## Request for Information#35

<b>Project Name:</b>	Construction of Victoria Park Arena and Brampton Sports Hall of Fame	<b>Contract No.:</b>	NRFP2024-232
<b>Customer Name</b>	City of Brampton	<b>Prepared By:</b>	Abdullah Hissamuddin
<b>Date Submitted:</b>	February 28, 2025	<b>Date Required:</b>	March 7, 2025
<b>Total Pages:</b>	1 of 1		
<b>Attachments:</b>	None		
<b>Description:</b>	Frost control clarification

Frost control clarification for Electric Duct Heaters  
EBC-1,2,3 (23 82 39)

## Electric duct heater shop drawings

DRAWING NO. MSC0-10LS-1002-0000

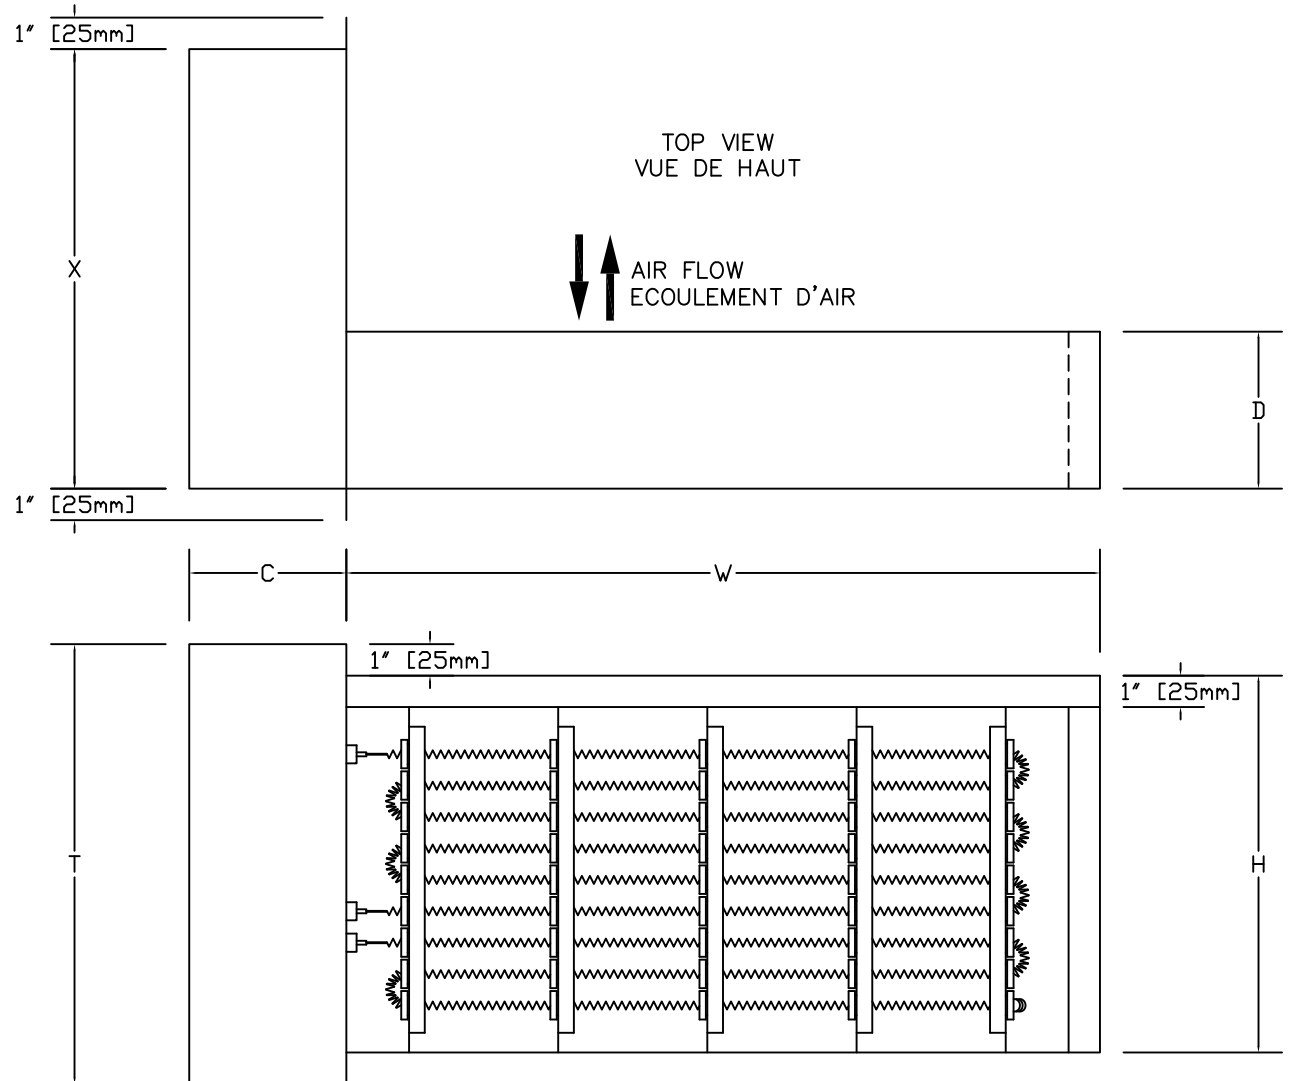
In response to the engineer's comment regarding the justification on frost control in the reviewed submittal (attached). We want to clarify that the frost control is actually included which is the thermostat (model CTH291) that will get mounted and wired to the 0-10vdc terminal block on the heater. They will set the temperature on the stat accordingly.

Please confirm or advise if this is approved/suitable. If more specific control is required it'll need to be confirmed through a site instruction.

FROST CONTROL NOT INCLUDED

This is accepted, thank you for the clarification.
